Comments from residents' group	Applicants' response
	22/1145/FUL	
	<i>We are grateful for the hard work you and the Urban Design Officer have put in to help the developer shape their proposal into something more acceptable. It is a pity this burden falls completely on yourselves as the local community is receptive to direct engagement with the developer, as we have had with other developers who have brought forward plans in the neighbourhood.</i>	The applicant has undertaken a number of days of public consultation and has been engaging with local stakeholders and members of the community, but must also respond positively to the relevant planning policies for the area and formal design input from officers. As such, we believe the proposals have responded positively to the consultation undertaken. We have never declined a request for a meeting and would be happy to meet with representatives from the residents' group.

Haven Road, Exeter EX2

Neighbouring Window Reference
7-14 Stream Court, Exeter EX2 8DL

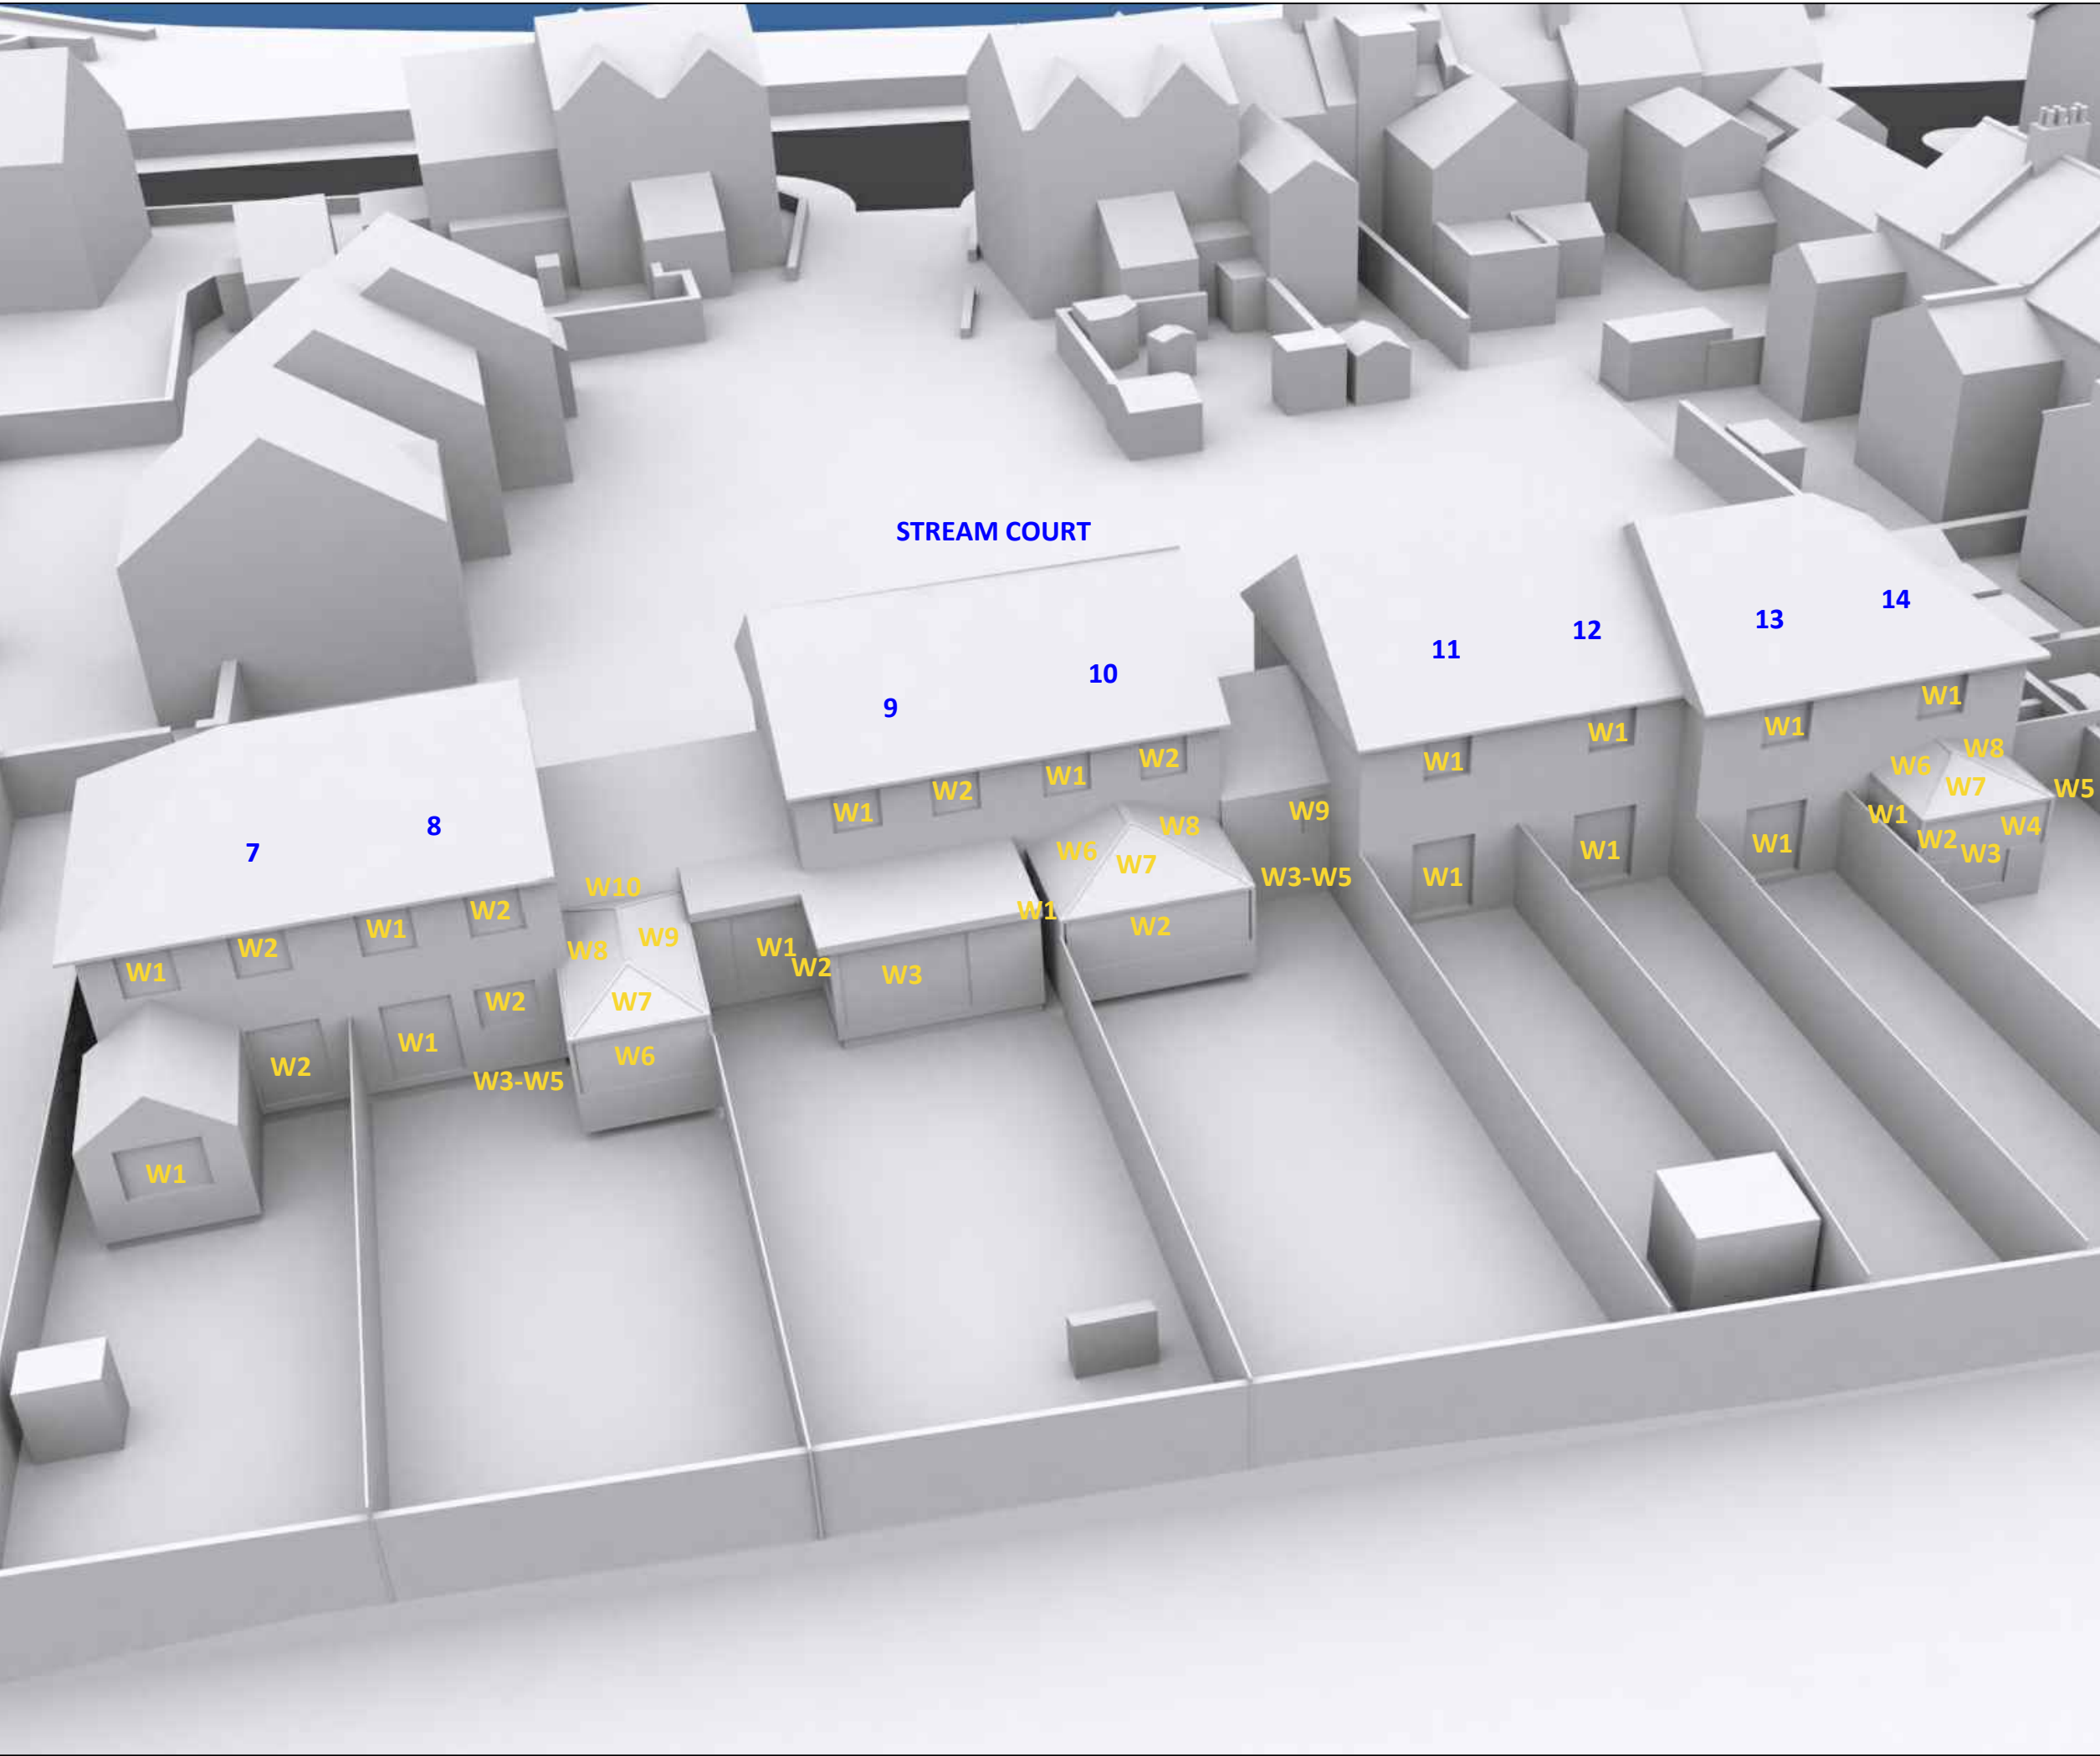
Comments from residents' group	Applicants' response
D13	The mass and height (26m) of Block D and its orientation (40 degrees from South) running parallel to houses 7-14 Stream Court produce an imposing north-facing wall towards these houses' sole ground floor room and overshadow their south-facing gardens.	Block D incorporates a low-level / mid-gap section and other areas incorporate purposeful stepping down of massing. This break in the building significantly reduces the perceived length of Block D while also allowing increased sunlight and daylight to the Stream Court gardens. All rear gardens to Nos. 7-14 Stream Court and the corner property of 18 Diamond Road have been reviewed for impact of the proposal upon sunlight to such rear gardens. For all these specific neighbouring properties, any applicable reductions meet the BRE Guide default target criteria in terms of any losses to sunlight to rear garden amenity areas in reference to the BRE Guide 2-hour sun to amenity analytical test.

D14	The loss of sun in our gardens is a result of overshadowing by Block D. It will change the nature of the gardens and their amenity use throughout the year. In Winter the ground is less likely to dry out and the moss and slime, which are normally present in the winter, will remain longer as the Spring and Summer sun is limited by our gardens' reduced total daily amount of sun. The BRE states that 'the sunlit nature of a site can be enhanced by preventing overshadowing'.	See D13 comment above.
